# ALVISO

Dear San Jose City Council,

Midpoint at 237 depends on your approval of rezoning permit PDC14-004 and project permit PD14-007. I suggest that the permit application, as is, should be denied, but if you deem it worthy, should be allowed with reasonable limitations including,

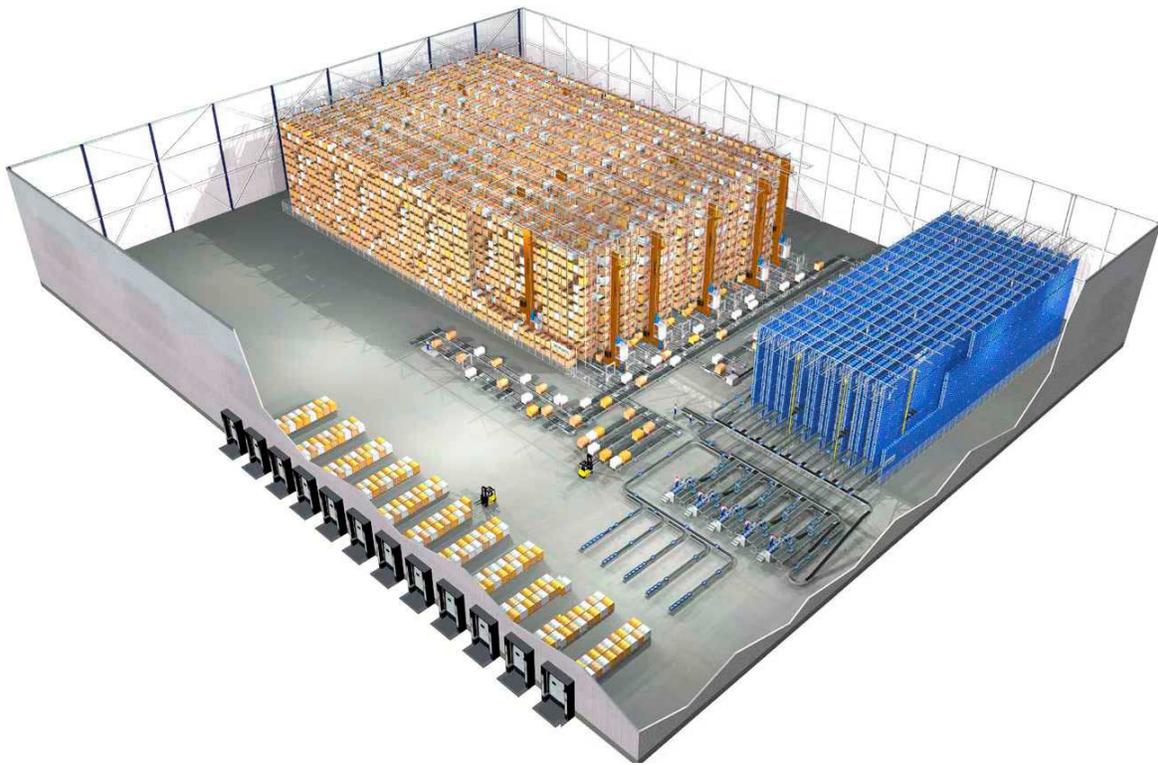
The applicant previously noted that the internal ceiling clear height is 28 feet, which is less than the industry average of 36 feet for warehousing, as a reason that the building is not a warehouse. In fact, 28 feet is the maximum height legally allowable on the site. Flood laws require a 12 foot dirt build-up. The building has a typical 5 foot ceiling clear height to roof peak distance, and the [Alviso Master Plan \[7\]](#) limits the allowable height of buildings in close proximity to the village to a height of 45 feet.

Manufacturing facilities generally have ceiling clear height of less than 18 feet (as below).

The plan set shows the buildings as using a grid of pillars type of construction. That is the least expensive kind of industrial building construction.

A grid of pillars style design (picture above) is conducive to high-tech automated storage/retrieval systems (picture below) that minimize human activity, and therefore provide few jobs. Furthermore, a grid of pillars limits the usefulness of the buildings for large manufacturing machinery or flexible assembly lines needed for prototyping or high-tech manufacturing processes.

### **Wind direction**

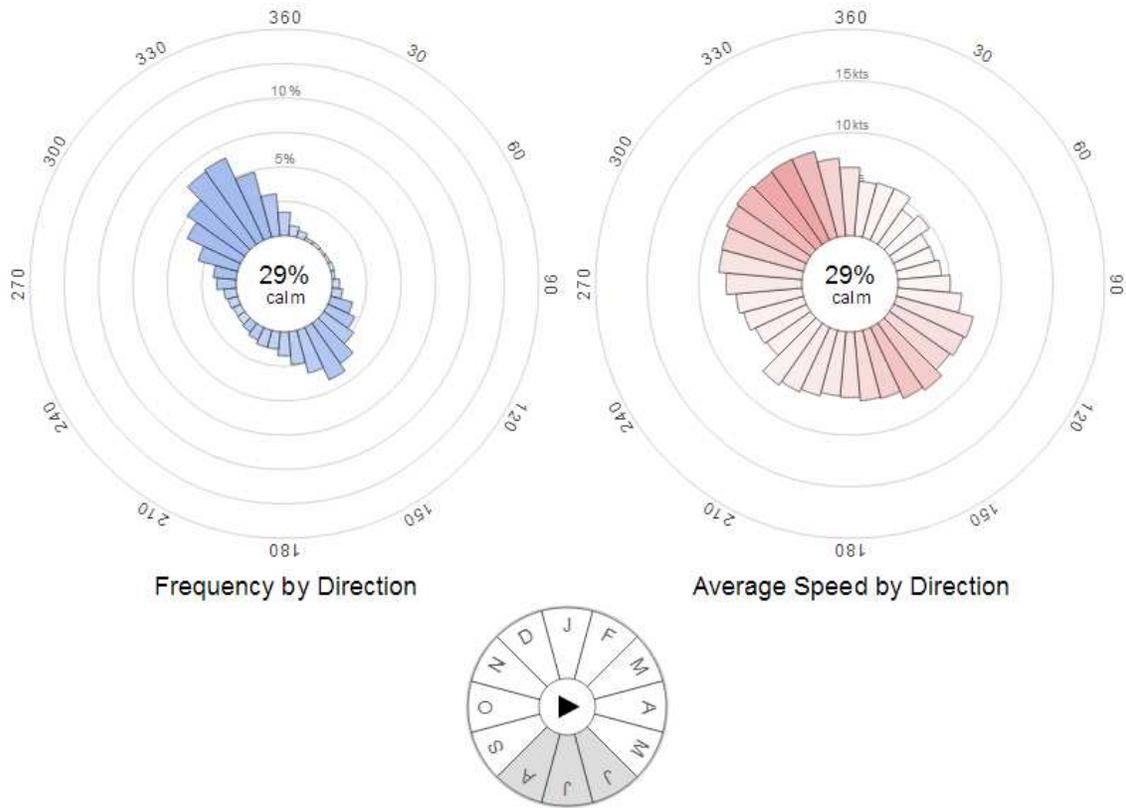
Wind direction was not considered in the Cisco EIR or the Midpoint Project EIR Addendum [9] concerning the effect of pollution emitted by diesel trucks on the site if used for warehouse distribution.

Below is a sketch-up of the building plan with the direction of wind flow from approximately 330 degrees from north. Air from the windward side of the westerly building will be shunted leftward, pour off the leftmost corner of the building, and move directly towards the George Mayne Elementary School.

It is therefore a concern of the community that diesel exhaust emitted on the northwestern side of the buildings, into low wind speed from the end of a shunting building directly upwind of the elementary school, park, and swimming pool will pose a health risk to children.

## KSJC: San Jose International Airport

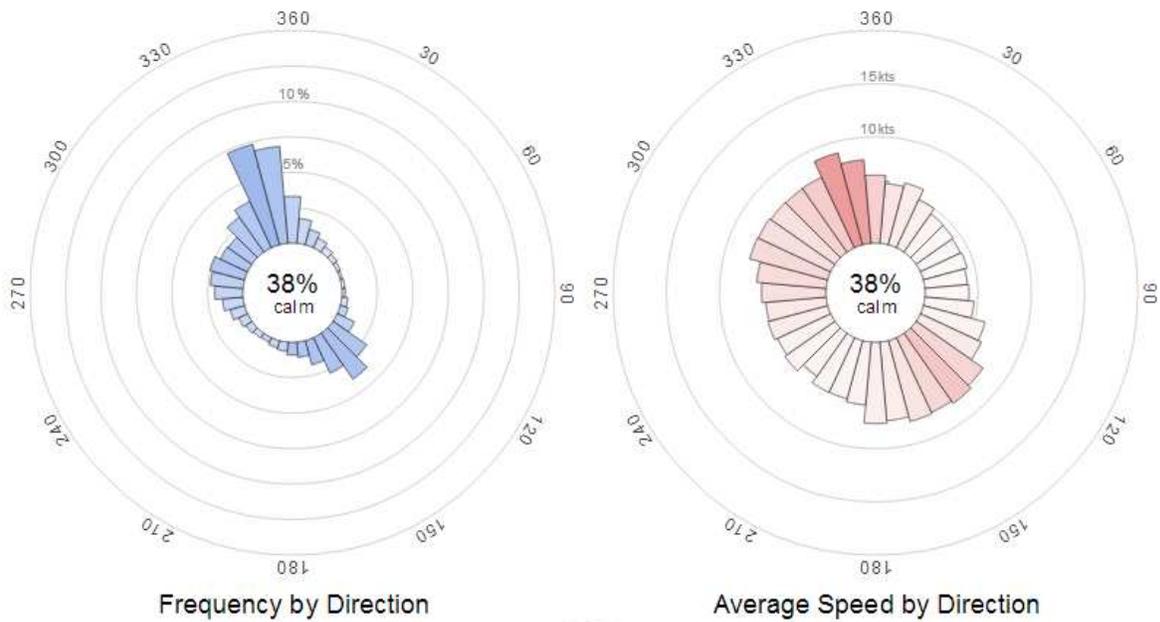
According to the web page <http://windhistory.com/station.html?KSJC> [10] the prevailing winds at San Jose airport during the school year are from about 320 degrees from north. It is about 345 degrees at Moffett Field. Calm and low speed winds are common. Below are the wind roses from the web site for each airport.

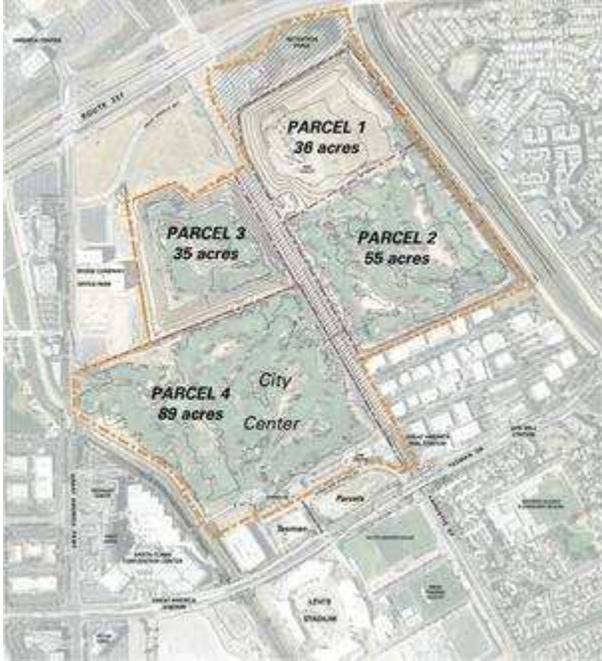
No study addressed the amount of diesel, as opposed to gasoline.

No study addressed wind direction.
